B & H OIL COMPANY

SITE PLAN APPLICATION #11-20

CONDITIONAL USE PERMIT #4-21

PLANS UNDER REVIEW: Site Plan, B & H Fuel Storage Tank Farm; prepared by Edward N. Herbert Assoc., Inc., 1 Frost Road, Windham, NH 03087; prepared for B & H Oil Company, Inc., 6 Starwood Drive, Hampstead, NH 03841; consisting of 18 sheets, with terms and conditions 1-8 on Sheet 1 and fourteen unnumbered general notes on Sheet 2; latest revision dated April 9, 2021.

SITE PLAN

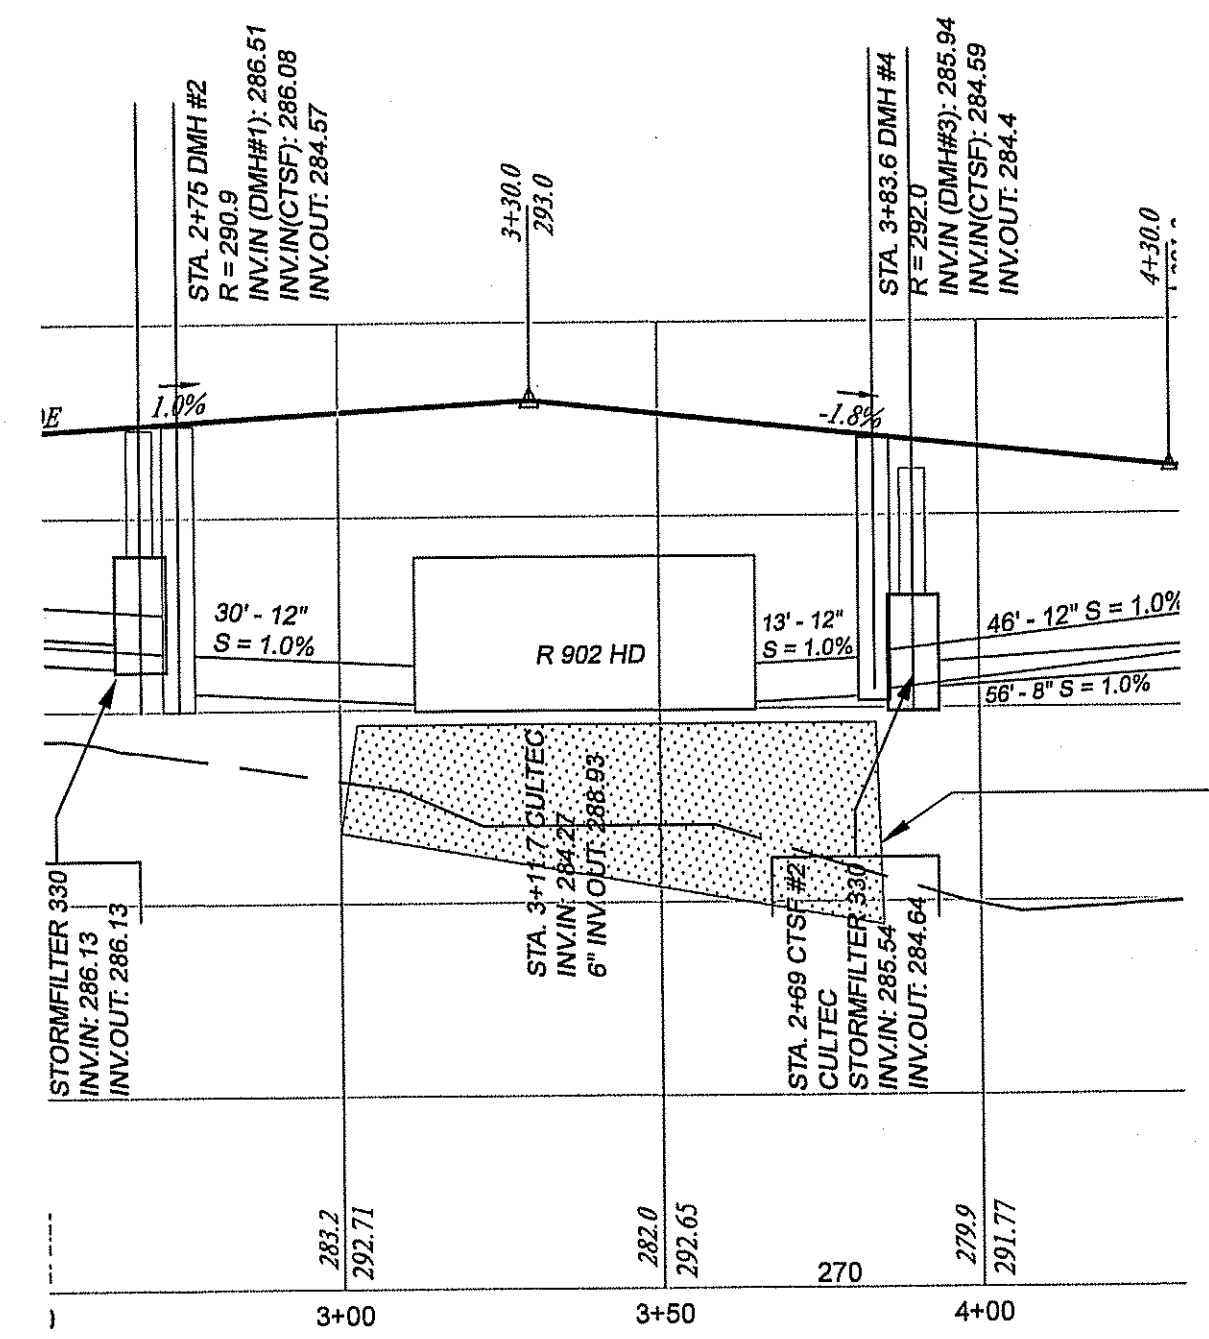
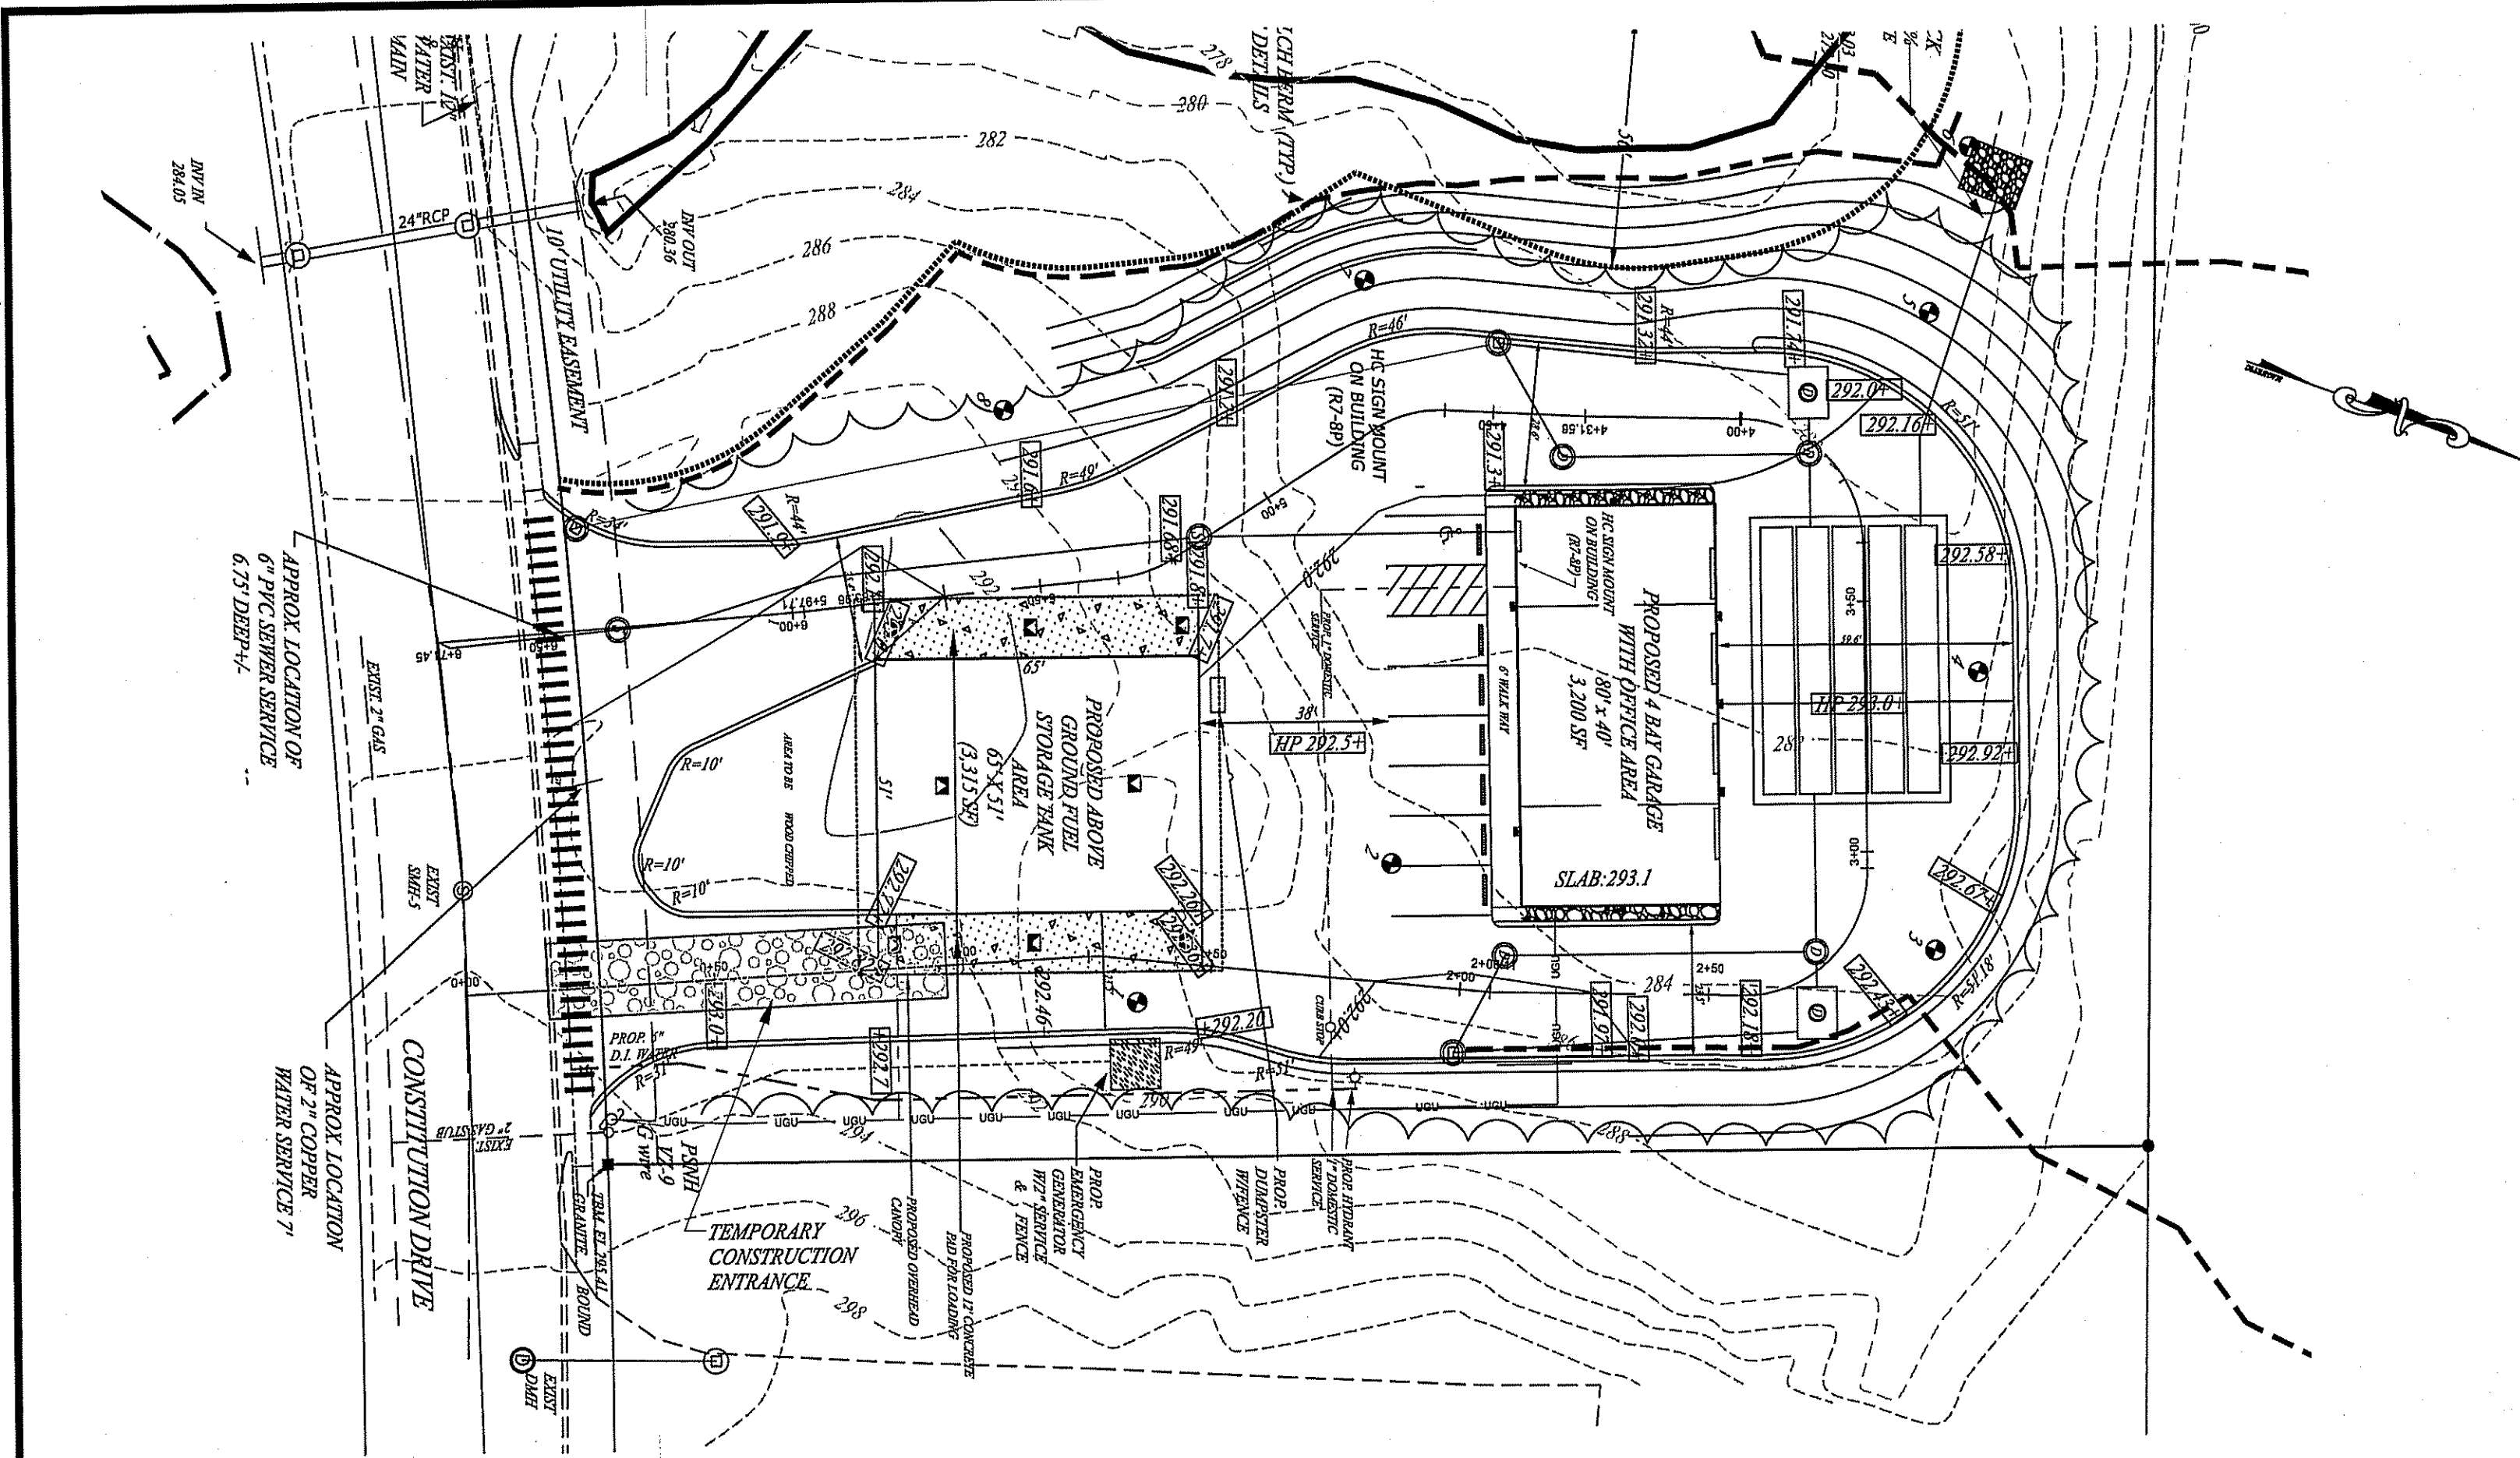
6. Stockpiling of construction materials is not allowed in the wetland buffer areas during construction.
7. The BioNet Erosion Control Blanket shown on sheet 7 of 18 shall be extended beyond the area shown to include coverage on all slopes 2:1 or greater near the wetland area to aid in slope stabilization.

5. The commission recommends that the BioNet Erosion Control Blanket shown on the revised General Site Plan drawing, sheet 7 of 18 (presented last night) be extended beyond the area shown to include coverage on all slopes 2:1 or greater near the wetland area to aid in slope stabilization.
